GOVERNMENT OF INDIA
MINISTRY OF ENVIRONMENT & FORESTS
Central Zoo Authority

F. No. 19-58/93-CZA(190)(Vol.III)(M) / 4221

DATE: 27.01.2014

Sub:- Design for the construction of various enclosures at Manipur Zoological Garden, Imphal, Manipur.

Design for the proposed construction of Sangai Enclosure Feeding Karawl cum Night shelter for Manipur Zoological Garden, Imphal Manipur.

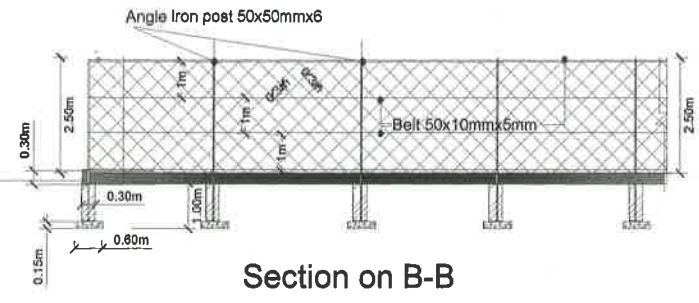
- Night shelter for the animal should be made of brick/ RCC structure and roof should be RCC slab instead of CGI sheet.
- Corrected copy may please be sent to this office for record.
